AAXICO

PMA PRODUCT RELEASE

AAXICO Technical Services (ATS) is pleased to announce PMA on the following Part Number:

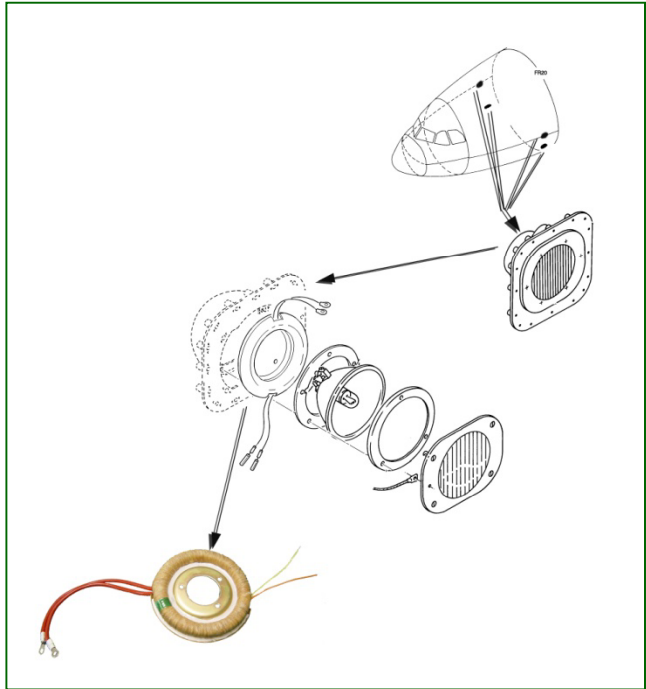
Advantages of Product Improvement: As part of making the design more efficient, the flux density has been raised, the number of wire turns have been reduced and changes to the wire gauge have been made. PTFE Shrink Tubing, Fiberglass Tape and High Temperature Ring Terminals have been introduced to improve the design which has yielded a 23% reduction in operating temperature. This improves performance and reliability, while still maintaining the fit-form-function requirements of the assembly. There are also cost savings over the OEM part.
